Subject/Concern: 08/09MY Accessory Rubber Mat Fitment

Models:
Range Rover Sport (LS) | VIN-range: AA215623 Onwards

Summary:
This bulletin is for information only. These rubber mats must only be fitted in 08/09 MY Right-Hand Drive vehicles. Under no circumstances should RHD 08/09 MY rubber mats be fitted to RHD 10MY vehicles.

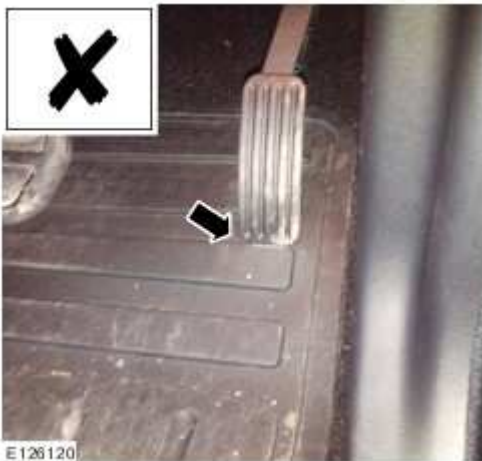
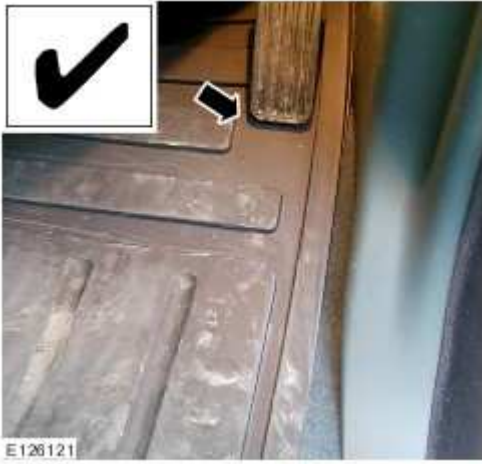
Cause: There is a risk of insufficient clearance between the 08/09 MY RHD rubber mat and accelerator pedal of 10 MY on RHD vehicles which may cause the accelerator pedal to stick in the downward position. Fit only RHD 10MY front mats (Service Part number for Front RHD Front Pair Rubber Mat - VPLSS0019) to 10MY Range Rover Sport. These mats were introduced on 10/04/09. The change to the rubber mat was to remove the Castellation feature in the area of the Accelerator Pedal. The condition of throttle pedal interference with mat affects Accessory mats produced after September 2007 and prior to 10 April 2009 when installed on 10MY Range Rover Sport RHD only.

- 1 . Incorrect floor mats shown.

- 2 . Correct floor mats shown.

Parts Required:		
Description	Part Number	Quantity
10MY Floor Mats Front Pair	VPL SS019	1
